## II RESPONSES TO COMMENTS

Pursuant to Section 15132 of the State CEQA Guidelines the following table identifies the persons, organizations, and public agencies who commented on the Draft EIR. The Notice of Availability/Completion (NOA/NOC) for the Draft EIR was published on February 11, 2021 initiating a 45-day public review period beginning on February 11, 2021 and ending on March 29, 2021. A total of 19 comment letters were received in response to the Draft EIR during the 45-day public review period, and one comment letter was received after the close of the public review period. Table II-1, below, provides a summary of the comment letters submitted on the Draft EIR.

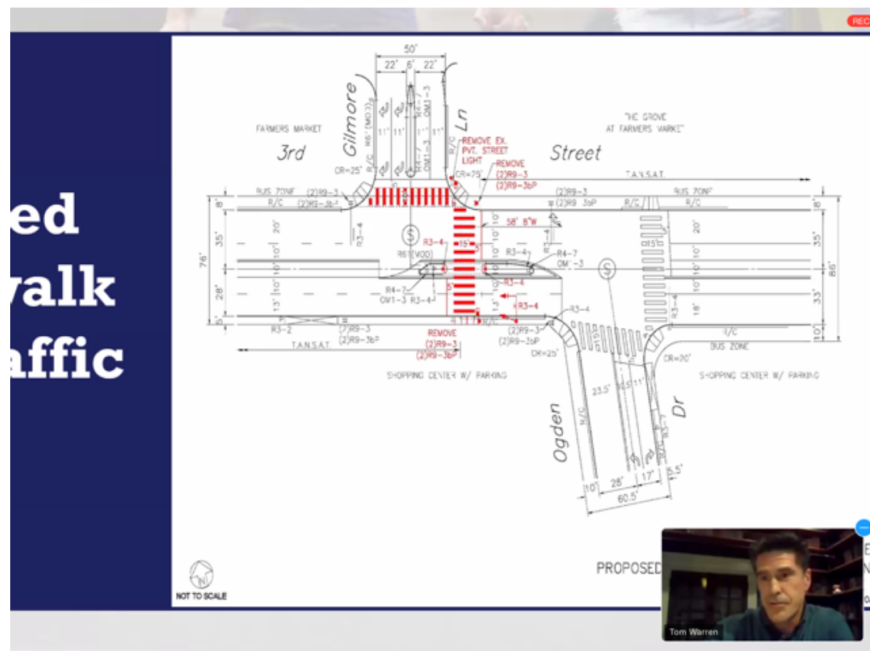
Nor does it take into account the presence of stopped DASH buses and Ross dumpsters on the east side of Ogden or the impact of 100 per cent [sic] of all vehicle traffic exiting the residential structure and the lion’s share of those exiting the retail structure needing to traverse the Southbound lane to access the northbound lane to reach Third Street at the intersection.

These dynamics will all be happening at the same time, on a local street with just 1 lane in each direction. It would be disingenuous to claim emergency response will not be affected.

Figure II-1  
Car Queuing Exhibit

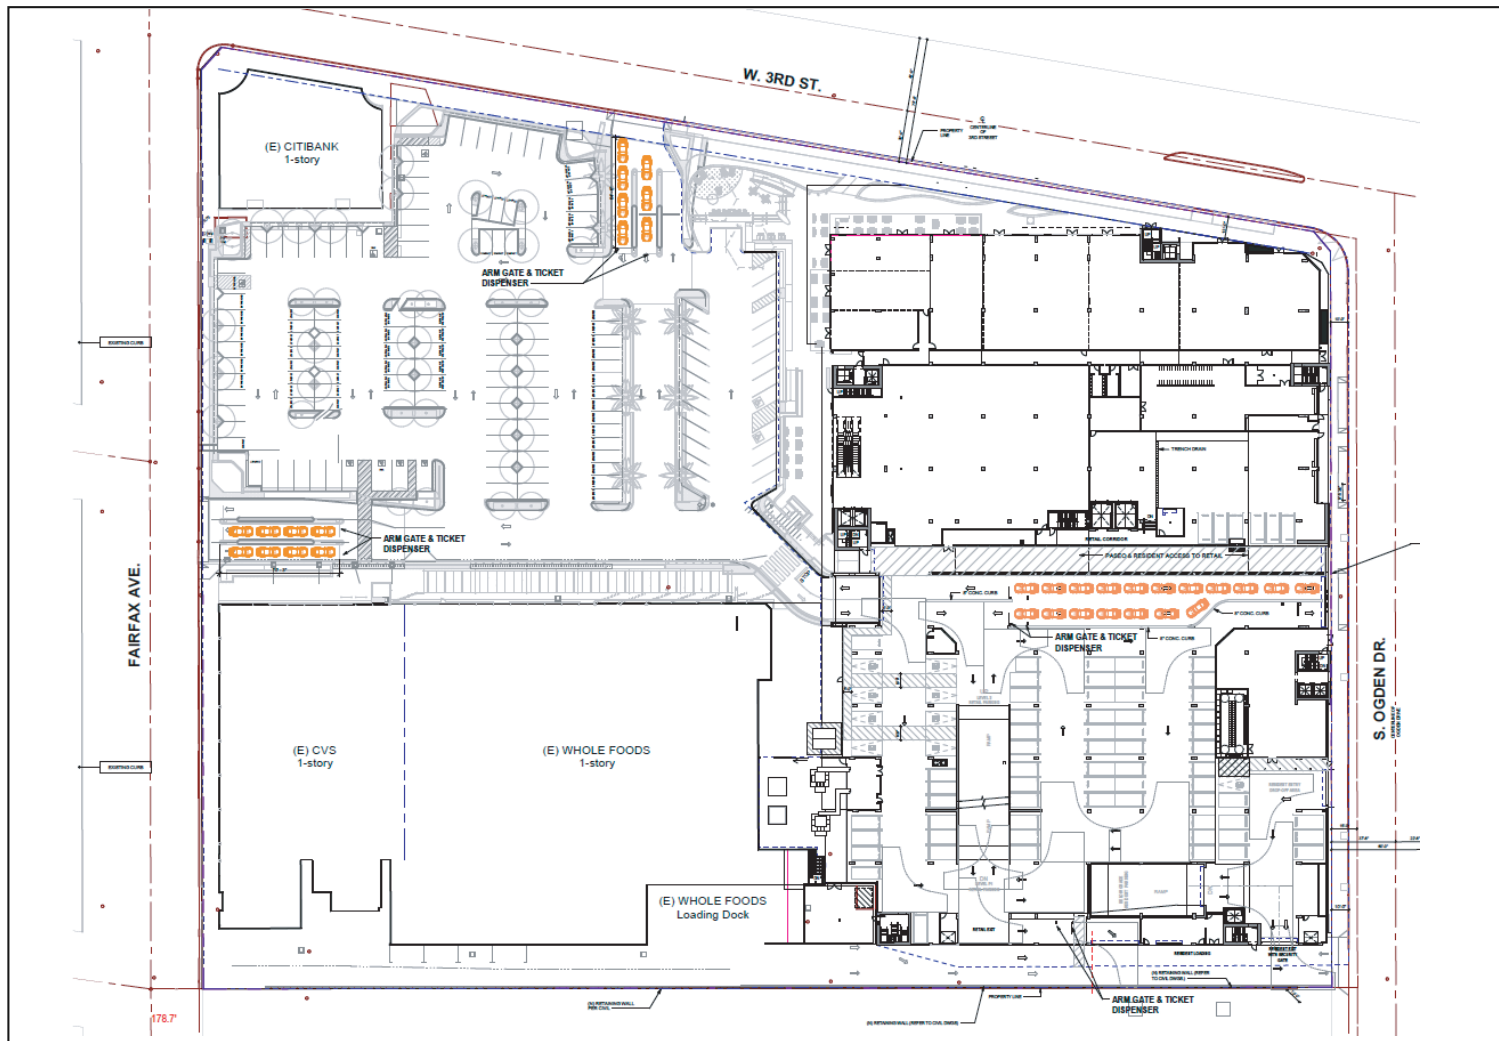
The analysis also fails to account for the impacts of requiring all vehicles to stop to take a ticket to enter the Proposed Project, or the volume of traffic coming off Third onto Ogden (pre COVID) on weekends trying to turn into Ross’s lot, or commercial vehicles and moving in each direction.

The commenter is concerned with spillover traffic from the Proposed Project's parking areas to W. 3<sup>rd</sup> Street and Ogden Drive. The State of California Office of Planning and Research updated Appendix G of the State CEQA Thresholds, to establish new criteria for analyzing traffic impacts based on vehicle miles traveled (VMT) in lieu of the level of service (LOS) methodology in January 2019. The City Council adopted the LADOT Transportation Assessment Guidelines (TAG), which includes the updated CEQA methodology and significance thresholds as directed under SB 743 on July 30, 2019, (and as amended in 2020). Accordingly, the analysis in Section IV.I, Traffic/Transportation of the Draft EIR addresses the Proposed Project's traffic impacts utilizing VMT methodology in compliance with CEQA. Therefore, impacts on area streets, including those along W. 3<sup>rd</sup> Street and Ogden Drive, from traffic congestion is no longer considered to be a CEQA issue pursuant to the TAG, and as approved by LADOT. Notwithstanding, it should be noted that the July 2019 Non-CEQA Traffic Analysis, provided in Appendix H.2(A) of the Draft EIR, applies the LOS analysis, which includes vehicle queuing and traffic congestion from visitor trips and delivery vehicles, for informational purposes.

With respect to vehicles queuing while drivers obtain a parking ticket when arriving at the Project Site, Figure II-10, Level 1 Floor Plan, in Section II. Project Description, of the Draft EIR, shows the vehicle access driveways provided at the Project Site and within the Proposed Project. For purposes of demonstrating the vehicle queuing capacity at all of the entry points to the Project Site and Development Site, a supplemental detailed vehicle queuing plan is provided in Figure II-1 – Car Queuing Exhibit, below. As shown in Figure II-1, below, vehicle access to the existing surface parking lot would continue to be provided along S. Fairfax Avenue and W. 3<sup>rd</sup> Street. At the time of Proposed Project operation, S. Fairfax Avenue would provide a queuing driveway of up to four car lengths with two ingress drive isles prior to the ticket booth for a total queuing capacity of eight cars. W. 3<sup>rd</sup> Street would include a two-lane queuing driveway that would allow up to seven cars prior to the ticket booth. It is important to note that these two queuing driveways are not a part of the Development Site and are beyond the scope of the Draft EIR. Nevertheless, these queuing driveways would help remove spillover traffic along S. Fairfax Avenue and W. 3<sup>rd</sup> Street. In addition, the queuing driveway inside of the Proposed Project's parking structure would be located off Ogden Drive. As shown in Figure II-1, the two-lane queuing driveway could accommodate up to 18 cars prior to the ticket booth. Additionally, a resident drop-off would be located within the parking structure to avoid vehicle queuing along Ogden Drive. Furthermore, LADOT's Manual of Policies and Procedures (Section No. 321) for driveway design require a 60 foot set back from the
